# Amendment Notice 1

**Licence Number** L7851/2002/6

**Premises**  
Mining Area C  
Mining Tenement ML281SA  
NEWMAN WA 6753

**Date of amendment** 5 October 2017

Premises map. The Premises is shown in the map below. The purple line depicts the Premises boundary.

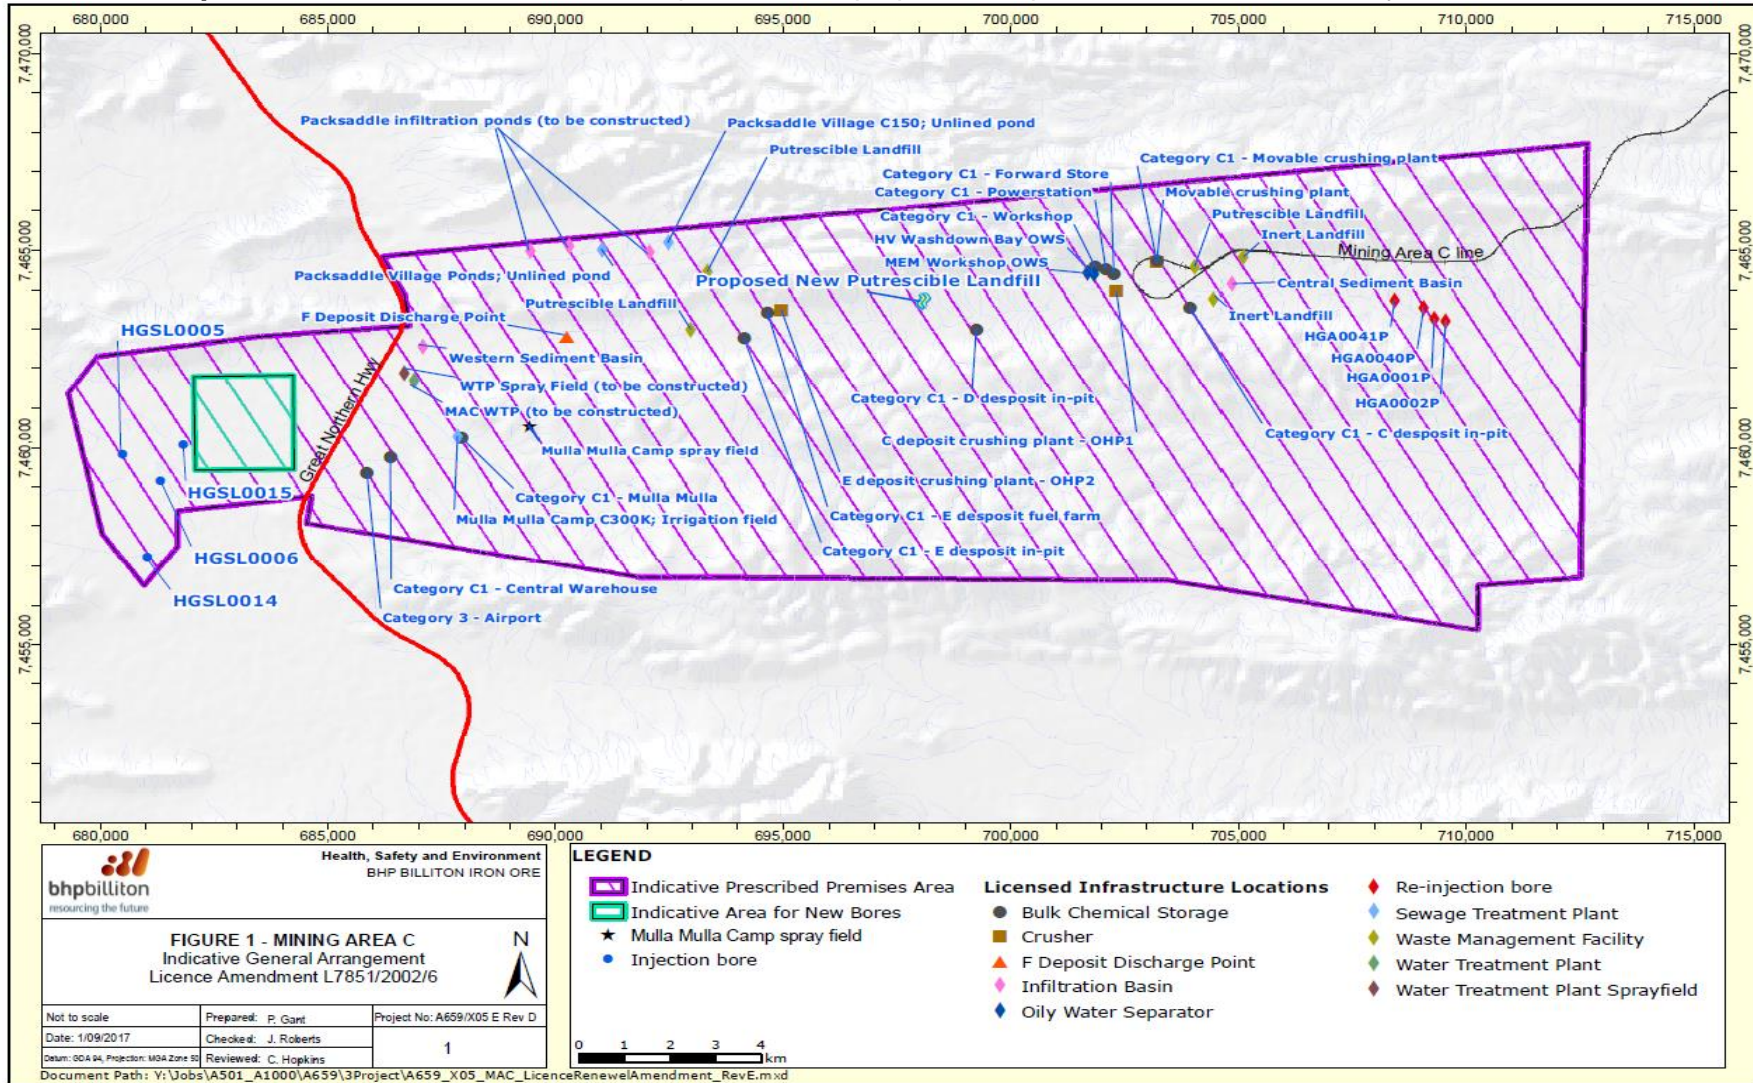
The Licensee has requested that the premises boundary be increased to include the Juna Downs MAR scheme.

21. The Premises map in Schedule 1 is deleted and replaced with the map in Attachment 1 of this Amendment Notice.
22. The Map of emission points and monitoring locations in Schedule 1 are deleted and replaced with the maps in Attachment 2 of this Amendment Notice.

The Delegated Officer considers the update to the premises boundary to be required to ensure the licence is enforceable. The Premises map and Map of emission points and monitoring locations have been amended via this Notice.
